Proposal for a mandate to amend UN gtr No 2 (WMTC)

Informal document GRPE-64-05
(64th GRPE, 5-8 June 2012,
agenda item 7)

Proposal for corrigendum to global technical regulation (gtr) No. 2
(ECE/TRANS/180/Add.2/Amend.1)

Figure A13-1: Example of a gearshift sketch

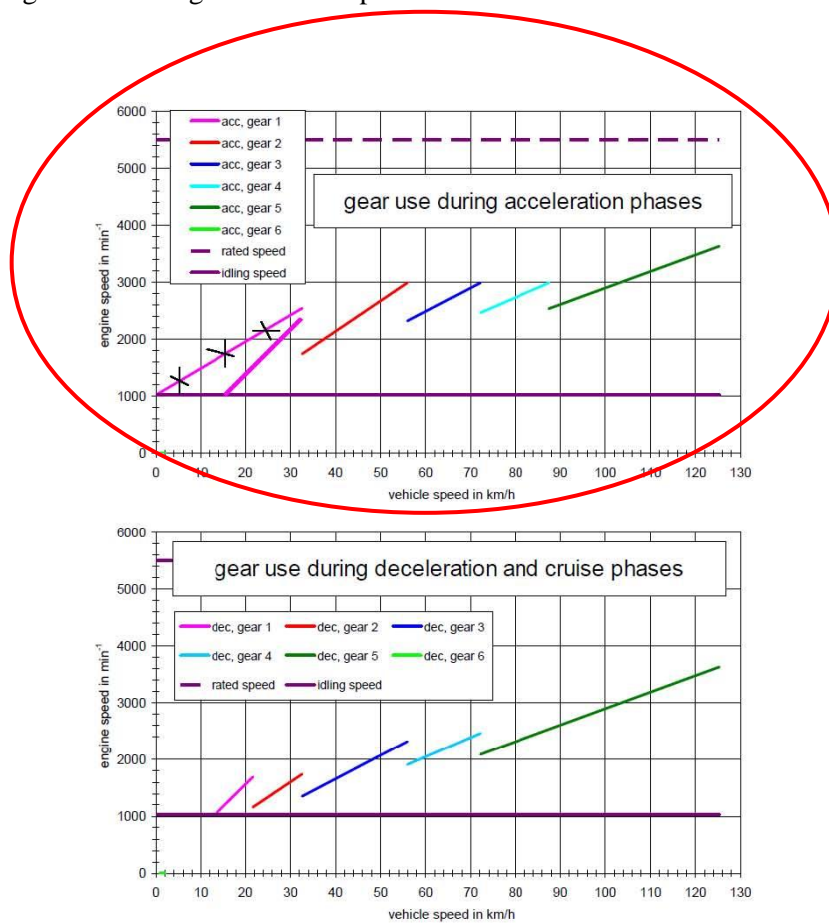
Annex 13, paragraph 1 Figure A13-1, correct the line for "acc.gear 1" in the upper figure for "gear use during acceleration phases" as shown below.

In the upper figure for “gear use during acceleration phases”, the acceleration gear 1 starts from zero, which is not correct.
